9 April 2026
317819

RE: Submission on Amendment C109moor Merrimu PSP

MERRIMU PRECINCT STRUCTURE PLAN – STORMWATER CONSIDERATIONS

Merrimu Native Vegetation Precinct Plan: Impact and Offset Review

MERRIMU - BUCKELYS ROAD
LAYOUT PLAN

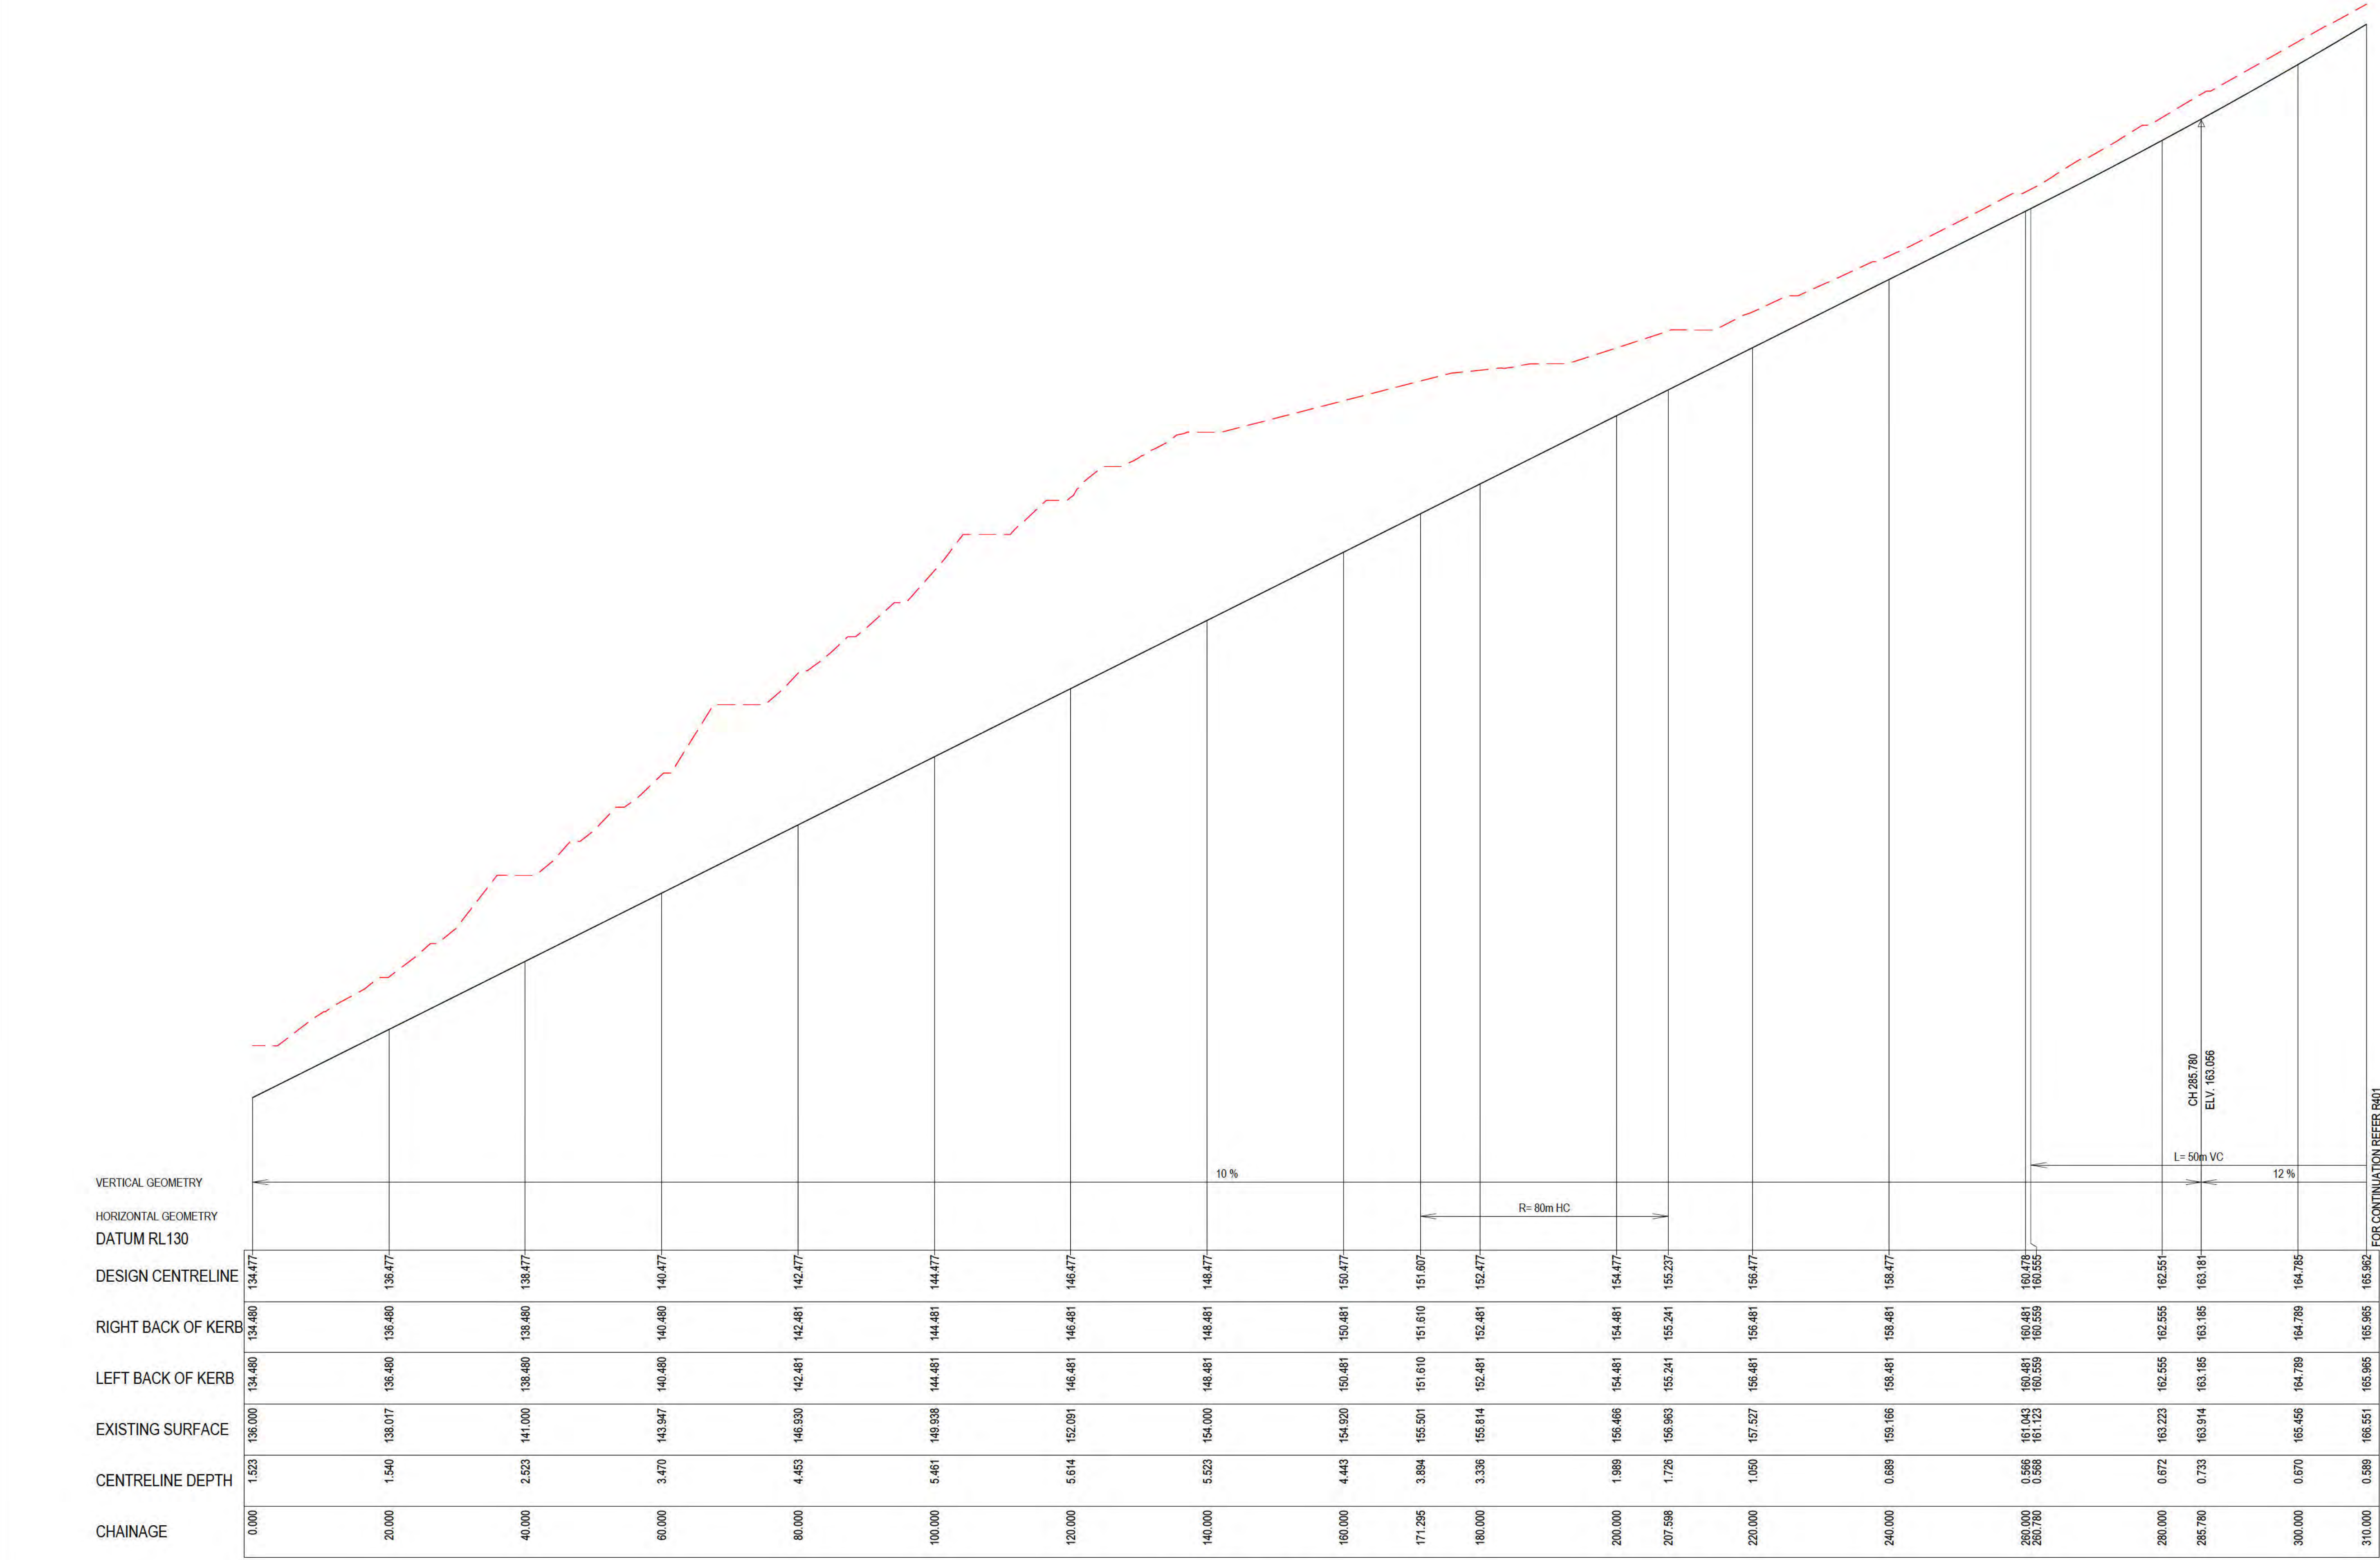
_____ concept significantly reduces earthworks when compared to the SMEC design, reducing cut depth from 11.9m to 2.8m. Land required for batters has been limited to depth of 10.5m instead of 30m as suggested by SMEC.

concept design demonstrates there is a substantial opportunity to reduce engineering works and reduce DCP project costs. RD-02 must be further refined to adopt the IDM and GAA standards relating to grade, and to require the least extent of earthworks and engineering as possible.
